***Re: Agenda Item No. 43 - Appeal of Beland Grading Permit #263768
Response to Master Report – File ID #18-0586***

GRADING PLANS
GRADING PLAN
 Parcel 2, PM 47/25
 75 Guadalupe Dr., El Dorado Hills, CA APN: 110-460-61

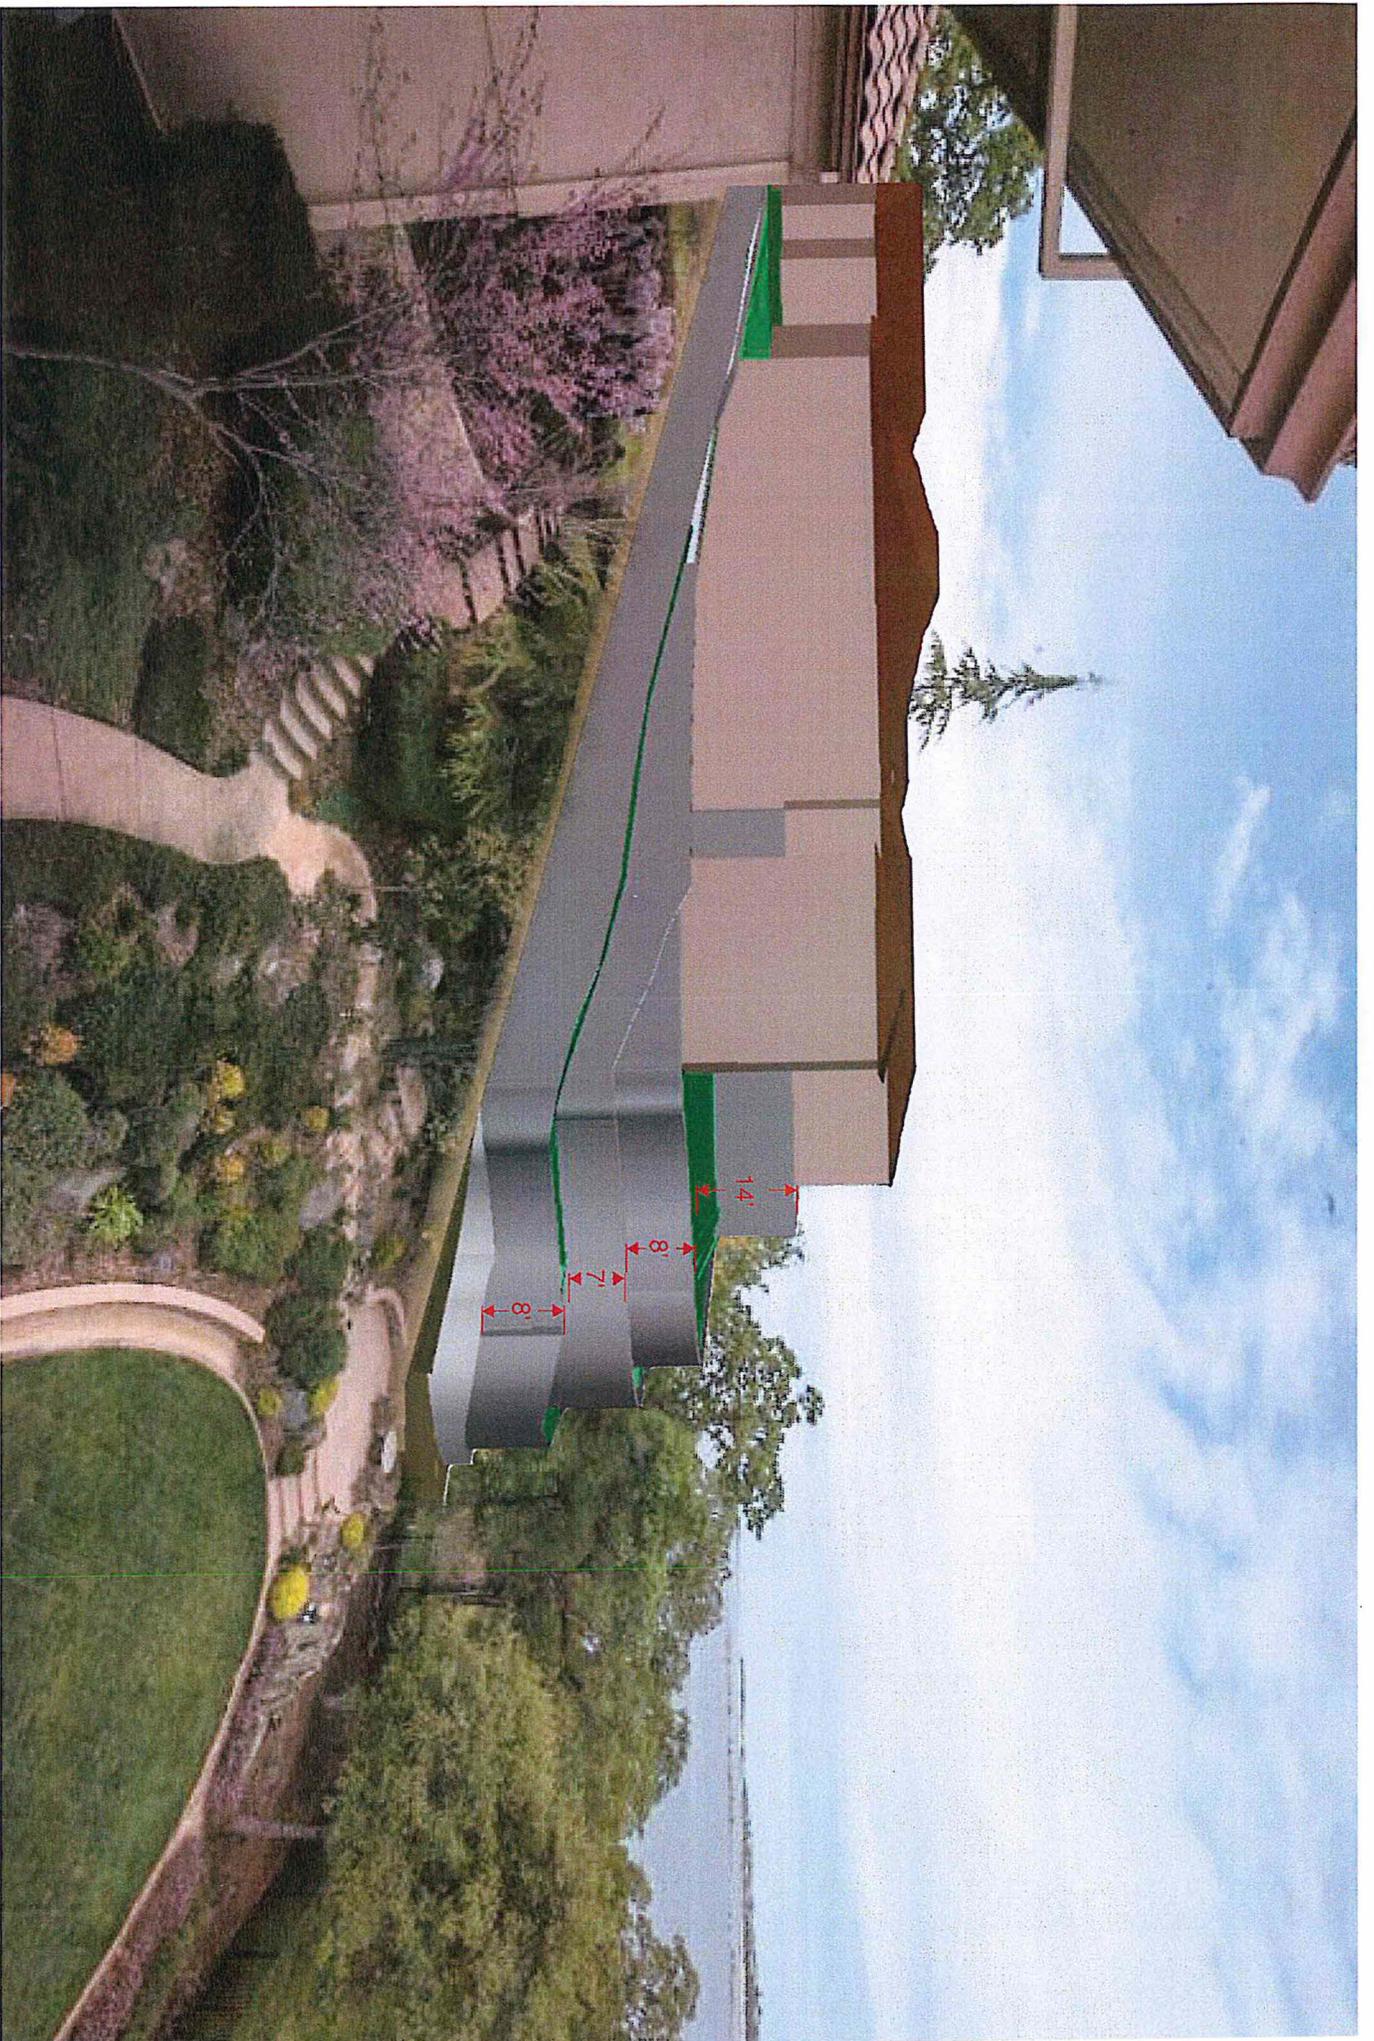
Instead of constructing within the existing topography, the current project proposes to import approximately 13,000 cubic yards of fill and approximately 1,300 cubic yards of concrete to effectively flatten out the site and accommodate the development of a single-story home. (see, Grading Permit #263768.)

This unusual circumstance overcomes the claimed Class 3 exemption and, in turn, creates significant environmental impacts that must be evaluated by the County. Specifically, the gross quantity of fill and concrete necessary to develop the project will exceed more than 1,300 total truck trips. In addition to severely impacting existing air quality through the production of criteria pollutants, construction activities will have significant adverse transportation impacts.

Project No: 10-18066G Exploration Date: April 20, 2018

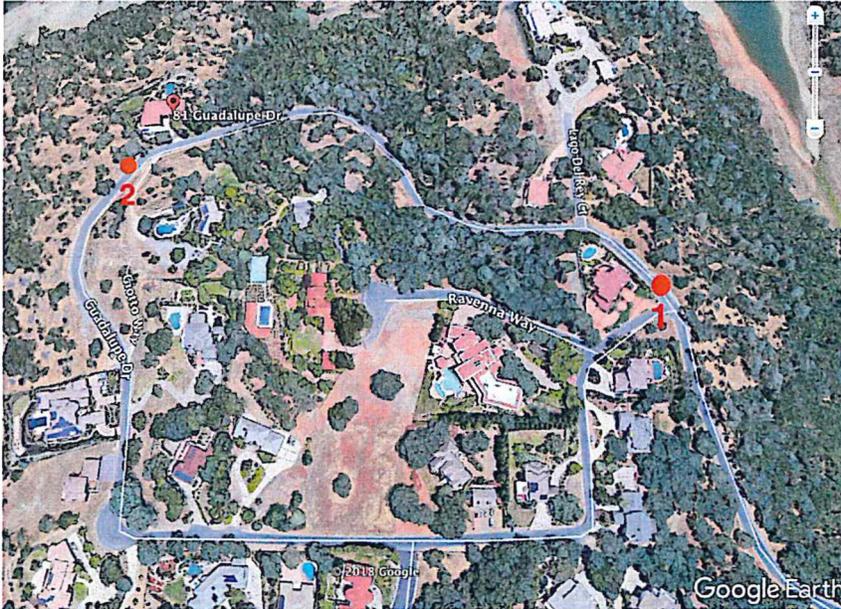
LOCATION 1: 3" Asphalt Concrete / 6 ½" Aggregate Base / subgrade soil - red-brown, silty sand with variable gravel (Unified Soil Classification: SM)

LOCATION 2: 2¾" Asphalt Concrete / 2 ½" Aggregate Base / subgrade soil - red-brown, silty sand with variable gravel (Unified Soil Classification: SM)

It is our opinion that the road structural section found in the core at location 1 is capable of supporting light to moderate vehicular traffic (e.g., weekly garbage truck) and at location 2 only very light vehicular traffic (this location does not meet the current structural section of 2" AC / 6" AB).

75 GUADALUPE DRIVE
EXISTING AND PROPOSED PROFILE ALONG PROPERTY

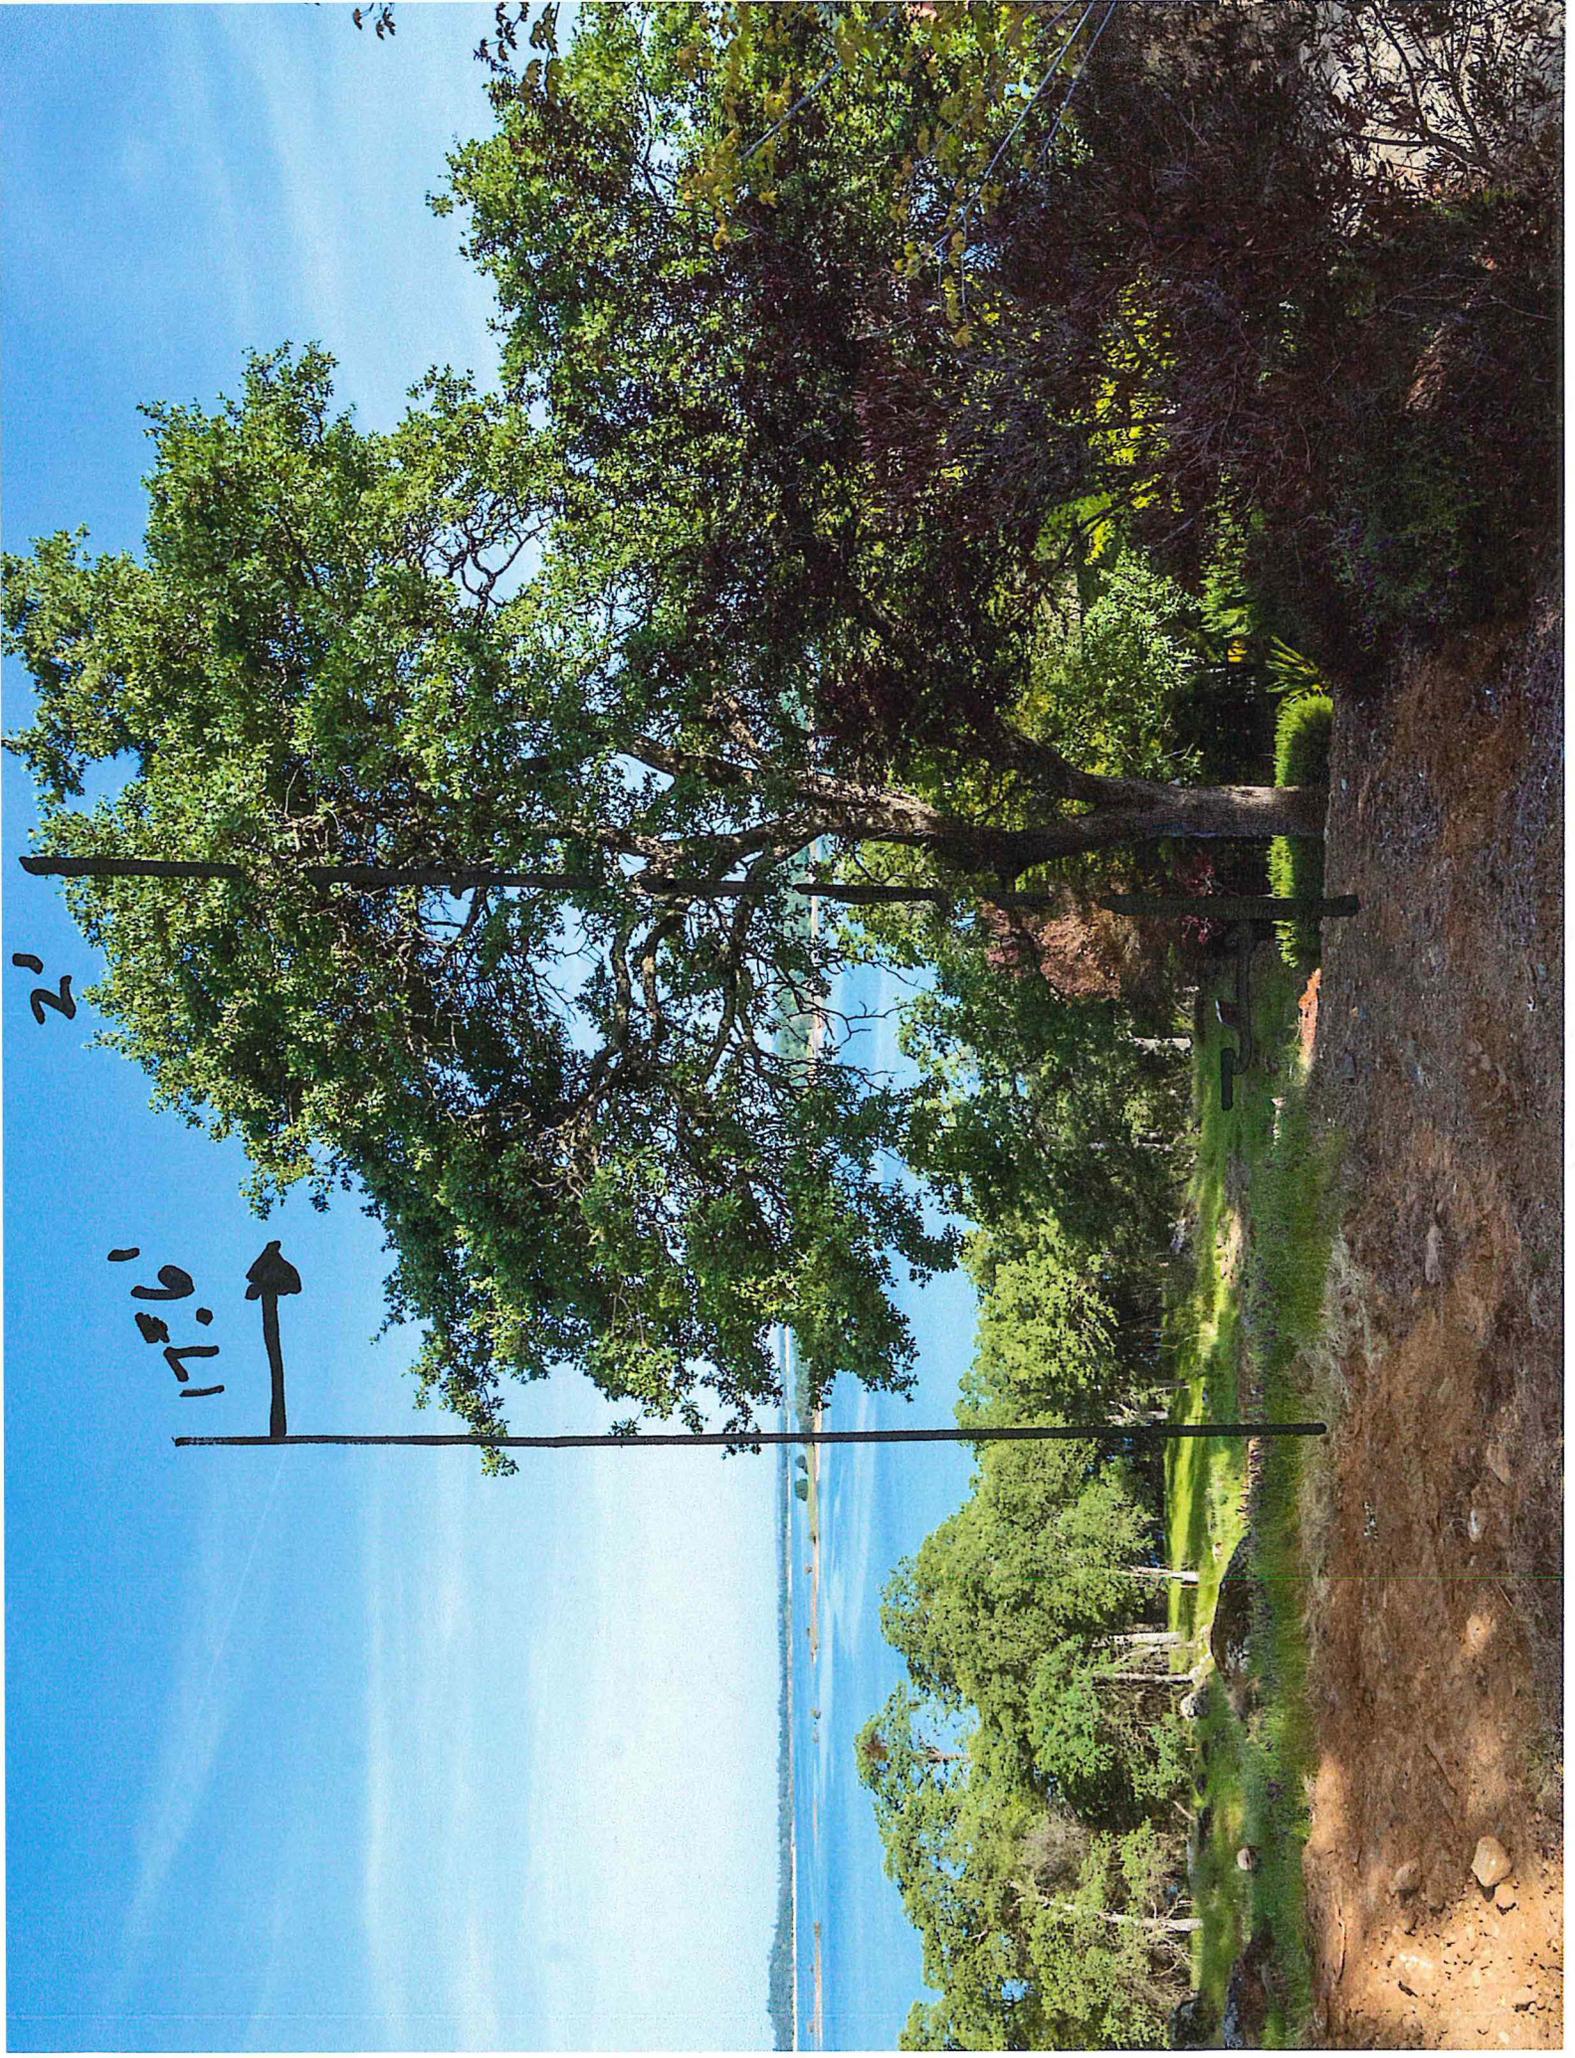
The lot had a full canopy of Oak trees. EDC approved 24 of them for removal and saved three. Two of the remaining three will die because of the proposed design – one a protected 37.9 inch diameter (119 inch circumference) measured 4.5 feet above ground level Heritage Oak. The permit application lists it as 36 inches – the minimum to be protected. An 11 inch diameter limb was already illegally removed from the tree. The proposed design shows a 6.4 foot retaining wall located 7 feet from the trunk and a concrete driveway behind it. No arborist would ever allow that!!! You are never supposed to construct

anything under the drip line of an oak tree. Ground level of the Heritage Oak is 600.35 feet. The finished pad of the upper garage is at 592.92 feet or 7.83 feet lower. The finished pad of the lower garage is at 581.61 feet or 18.74 feet lower. The Heritage Oak has little chance to survive.

The second Oak tree is on the opposite property line and is an 18" Oak at an elevation of 584.17 feet. There is a proposed retaining wall of seven feet to two feet located two feet from the trunk of the Oak. The Oak tree leans heavily to the subject property with approximately 75 percent of the drip line (17.6 feet) over the subject property. In addition the concrete driveway is 3 feet from the Oak trunk. The driveway entrance is at 596.73 feet and the driveway at the Oak tree is at 589 feet resulting with 4.83 feet of dirt and concrete within the drip line. Again this Oak tree has little chance to survive.
